ADDENDUM

EIA PROJECT REPORT- PROPOSED 400KV POWER TRANSMISSION LINE FROM LOIYANGALANI TO SUSWA

PROJECT PROPONENT: **KETRACO**

JULY 2008 - UPDATE MAY 2013

Figure 1: Alignment Change 1

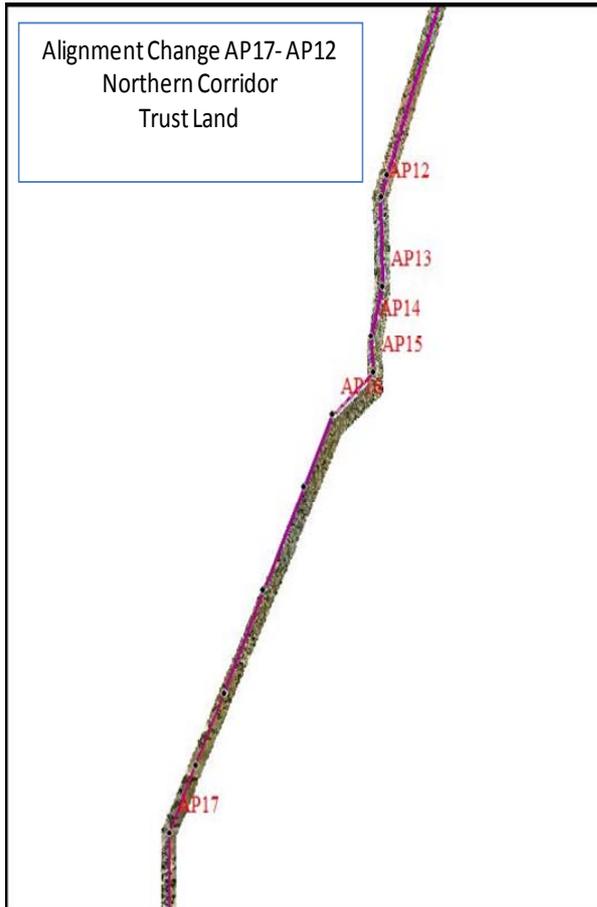
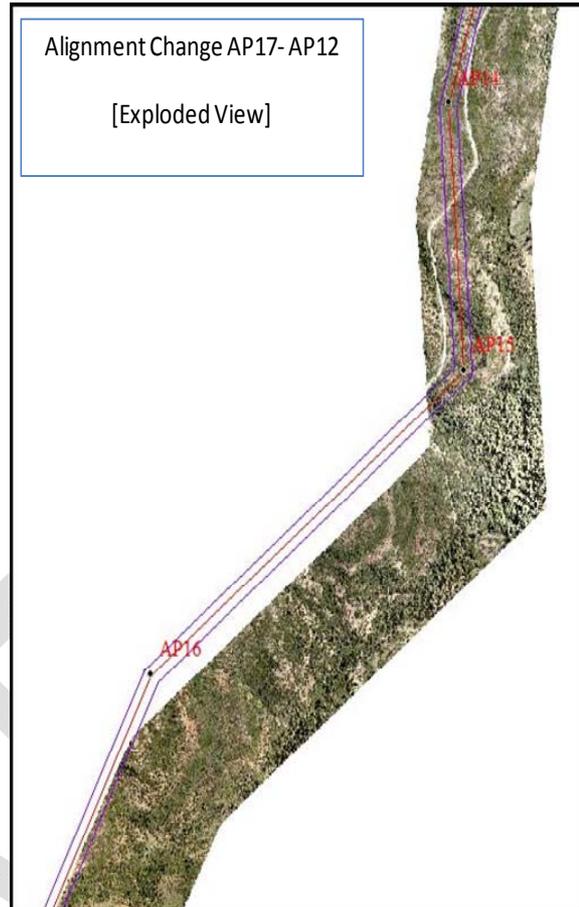
- In the northern corridor, two (#2) minor rerouting of the way-leave trace were agreed between the contractor and Ketraco. These changes came about following identification of an inaccessible areas that would be difficult to access during construction or when undertaking maintenance. The net result of these changes from a technical/ construction perspective are access will be improved, design/ technical and construction impacts will be reduced and the route will be shortened marginally; from angle point AP17 to AP12 with UTM coordinates of (229269 and 10130969) and from AP10 to AP08 with UTM coordinates of (242346 and 10130969).

- From an environmental and social perspective the way-leave area where the changes are necessary is Trust Land, is unoccupied and the land is mainly used from grazing purposes by pastoralists. Overall the impact of these changes will provide a marginally improvement, of shorter length, compared to the original alignment. The figures below illustrate graphically the alignment changes. The alignment deviates a distance of (300m) from the way-leave centre line. The LIDAR image is 400m width.

Figure 1.4 Location of Cedar Forest
(Western red line is the existing 200kV line and Eastern red line is Loiyangalani line)

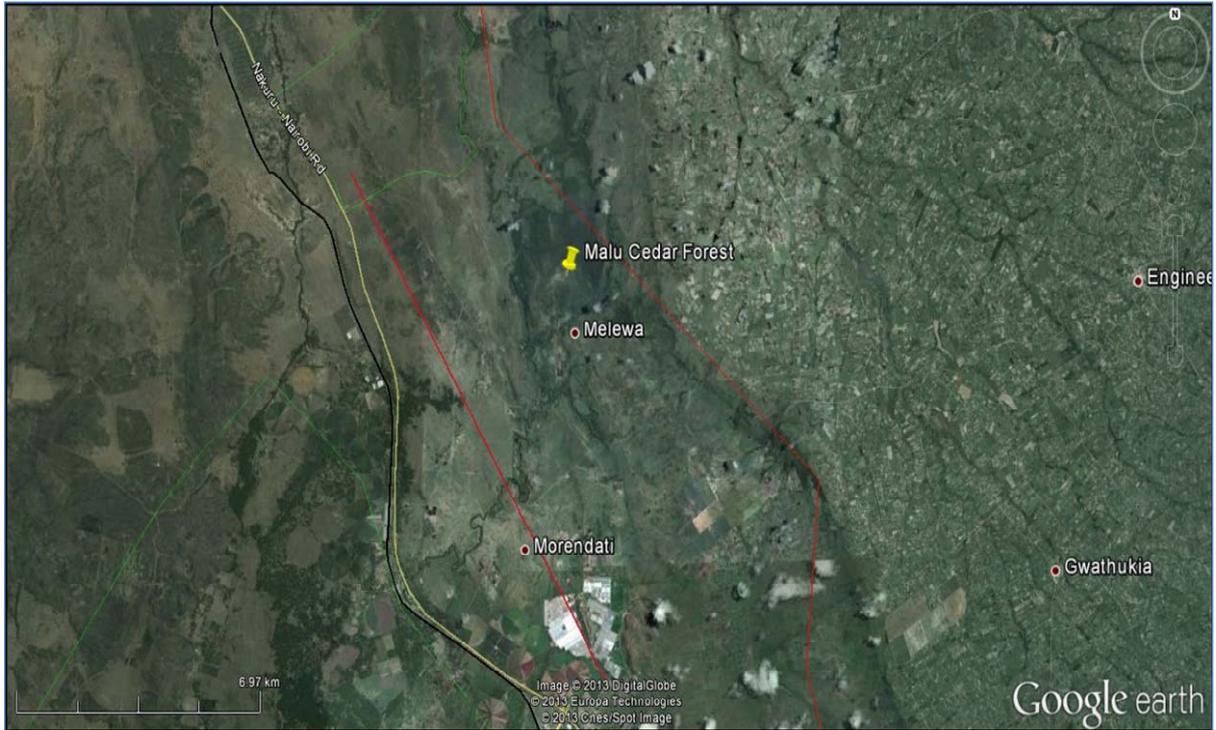
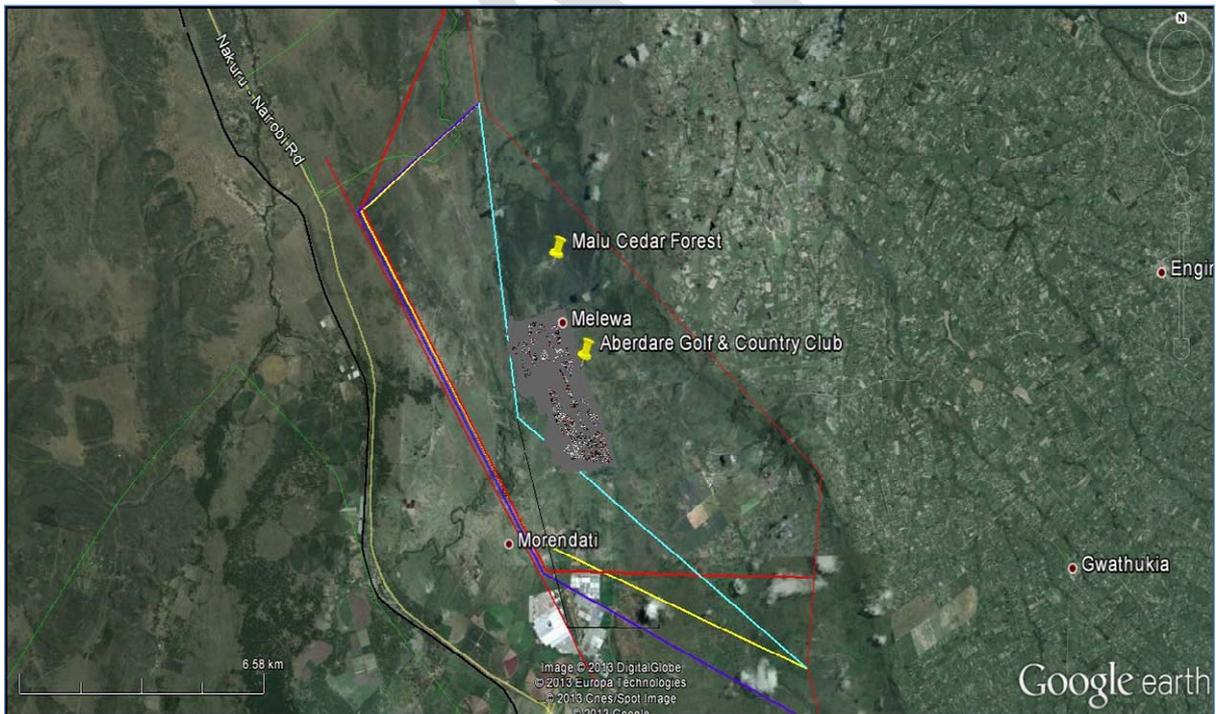
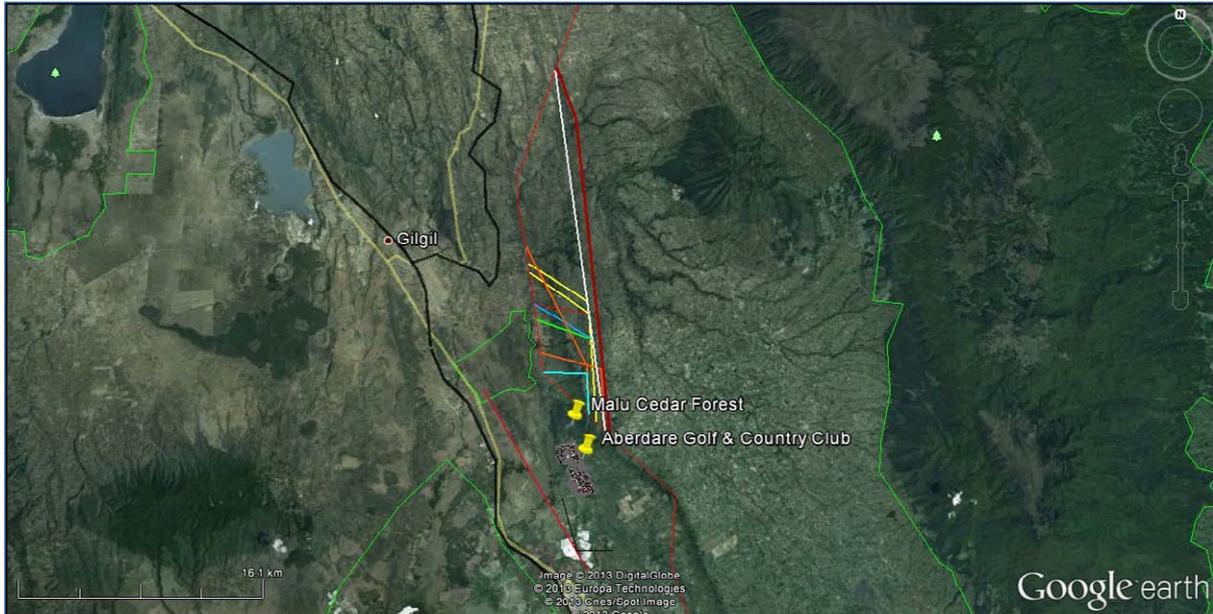
In the southern sector, between the then angle towers AP31 and AP28 with UTM coordinates of (216798 and 9932418), an objection was raised by a private company on environmental grounds citing; that the proposed transmission route would traverse one of the last remaining indigenous cedar forest and as such have devastating impact on biological diversity and the aesthetics of the land. Amongst other issues the claimant also cited impacts to tourism, constraint to the flight path of the private airstrip, health, and land value as other considerations.

Ketraco, taking cognisance of this objection investigated a number of realignment options. The two main potential realignments to avoid the cedar forest were to reroute to the west or east of the forest. Various realignment options were considered and illustrated the below figures. In each of the alignment variations cognisance was taken of the environmental, social, commercial, and constructability aspects, and as a point of clarification in this addendum an assessment of cumulative impacts¹ of the potential now existing and or proposed future transmission lines as well as infrastructure projects in or around this location including various other constraints that may impact either positively or negative upon the preferred alignments has been investigated.

The existing 220kV line curtailed any possibility of rerouting the Loiyangalani line in a westward direction. The flower farm in combination with Aberdare Golf and Country Club also curtailed alignments through the centre section of this valley. Following analyses of all the options the only alternative was a route along the Malu foothills to the east of the cedar forest. The various options are depict in the figures below. All of which had challenges.

The selection resulted in a slightly shorter route, but over undulating hills with poor topography and through a more densely populated area consisting of small scale farming that ultimately increased the number of affected plots and PAPs (project affected person) along the original route but negating the impact on the environment/ cedar forest. There are two options i.e. the (red & white) straight lines on the eastern side curtailed any meaningful investigation along this far eastern options as this area had been earmarked for the Ethiopian Kenyan interconnector route as discussed below.

The outcome of the study and optimum way-leave route selected was a realignment of the transmission line to the eastern side of the Malu Lodge avoiding any impact on the cedar forest and away from the adjacent foothills. Existing large infrastructure projects in this location are flower farms and of late a new development, Aberdare

Figure: 1.6 Malu Eastern Alignment

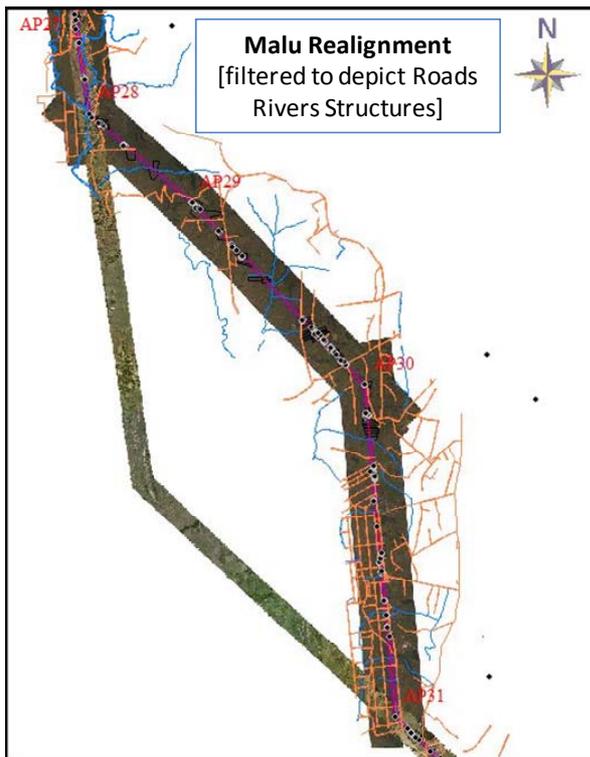
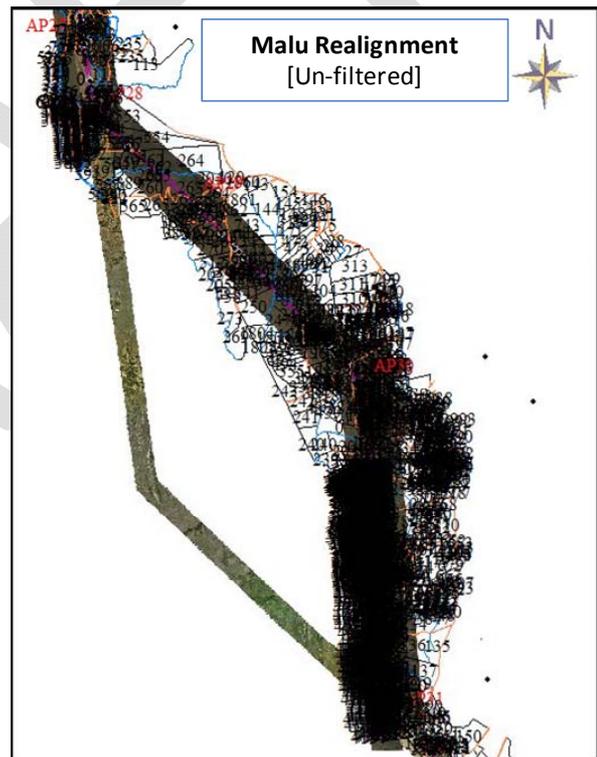
The above figures depict the eastern route selected to avoid the cedar forest as well as the infrastructure project existing in the valley which limited the options to realign the route in a westerly direction. Figure 1.6 is a filtered projection showing the LIDAR base image and the existing road network (tan colour) and the rivers

(blue colouring). The black dots indicate structures that exist in the way-leave trace. These structures need to be relocated within the existing plot or if displaced due to the extent of way-leave encumbrance then these PAPs need to be resettled.

Figure 1.7 above is an unfiltered view from Global-Mapper software showing in black the extensive cadastral mapping detail of the various plots and their LRN (land registry number).

Figure 1.8 Malu detailed LIDAR Image

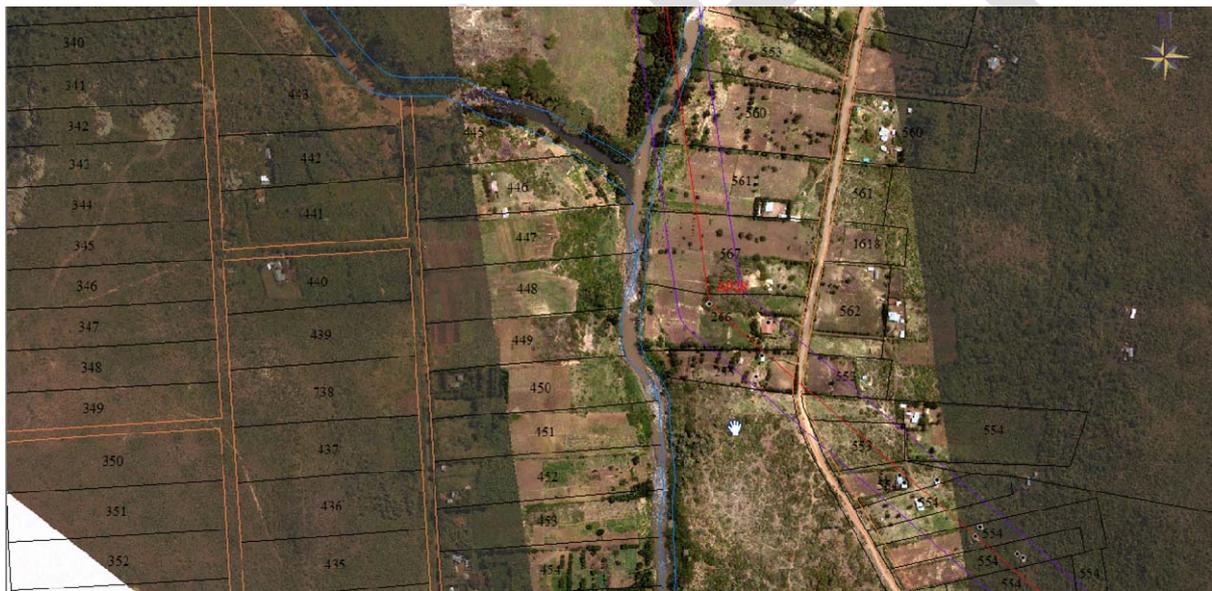
Figure 1.8 below is an unfiltered exploded view of the small scale farming that exist in this locality and are affected by the way-leave trace. The Malewa river tributaries, roads, way-leave trace, plots and their boundaries, registration numbers as well as affected structures can clearly be seen in detail.
